# STAFF ANALYSIS

| **CASE NO.:** | Z-25-1247529 | **File ID #:** 2025-0628 |
| **Request:** | Rezone property from C-2 (General Commercial) zoning district to HR-1 (High Density Residential-1) zoning district to allow single-family attached, and multi- family developments. | |

**Site Plan Review (*Illustrative Site Plan - Everstead at Embry Hills, dated 10/17/25*):**

## PAINT COLOR SCHEME D
## UNIT TYPE 312

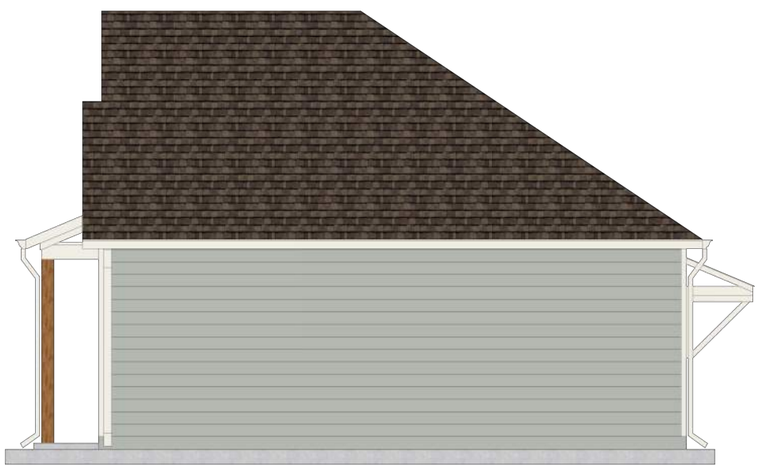
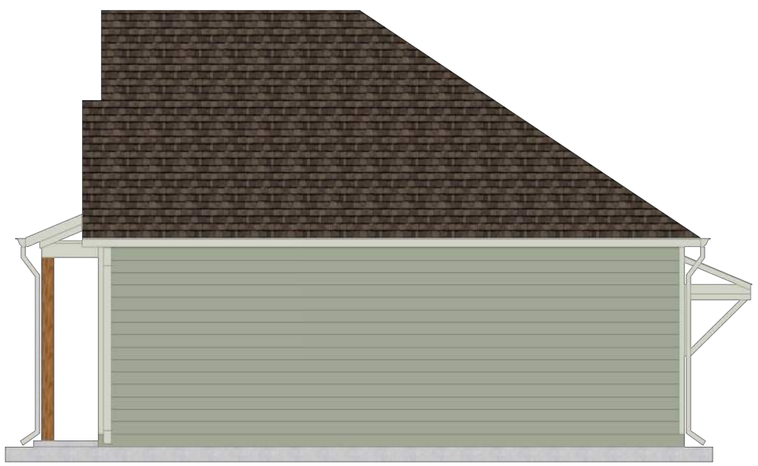
- **Architecture & Design:** To better complement the natural landscape and the housing redevelopment directly north of the site, Staff recommends a combination of ***Scheme D*** and ***Scheme E*** (enclosed) from the provided BTR Color Scheme Elevations. In addition, incorporating red-toned rick into portions of the facade, similar to that found on many of the surrounding ranch-style homes, would further reinforce consistency with the area's established development pattern and character.
